Technical Service Bulletin (TSB)

Transmission Rattle

REFERENCE:	TSB: 21-062-26 GROUP: 21 - Transmission and Transfer Case	Date:	September 25, 2026	REVISION:	—
VEHICLES AFFECTED:	2026 (DT) RAM 1500 Pickup This bulletin applies to vehicles built on or after April 01, 2026 (MDH 0401XX) and on or before July 10, 2026 (MDH 0710XX).			MARKET APPLICABILITY: ☒ NA☐ MEA ☐ EE☐ IAP ☒ SA☐ CH NOTE: This bulletin applies to the North America and South America markets.	
CUSTOMER SYMPTOM:	Customers may comment on the following: Rattle noise coming from the transmission.				
CAUSE:	Transmission oil heater mounting nuts are under torqued

Fig. 1
Transmission Oil Cooler Mounting Nuts

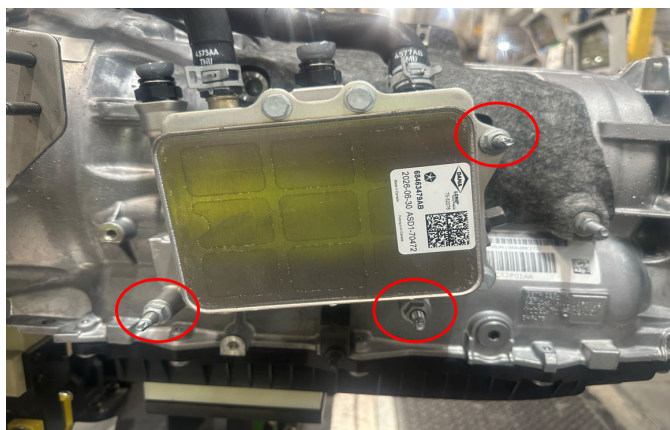
This bulletin involves inspecting and possibly tightening the transmission oil heater mounting nuts to proper specification.

1. Is the vehicle on the RSU VIN list?
 - YES >>> Proceed to [Step 2](#).
 - NO >>> This bulletin does not apply. Perform further diagnostics.
2. Raise and support the vehicle. Refer to the detailed service procedures available in DealerCONNECT/Service Library under: Service Info> 04 - Vehicle Quick Reference / Hoisting / Standard Procedure.
3. Torque the transmission oil heater mounting nuts to proper specification [Fig. 1](#). For torque specification refer to the Torque Specifications - Transmission Oil Cooler And Heater table available in DealerCONNECT/Service Library under: Service Info> 21 - Transmission and Transfer Case / Automatic - 8HP75 / Heater, Transmission / Removal and Installation.

NOTE: If nuts are found to be loose and there is evidence of transmission fluid leaking, follow standard warranty processes to repair and claim.
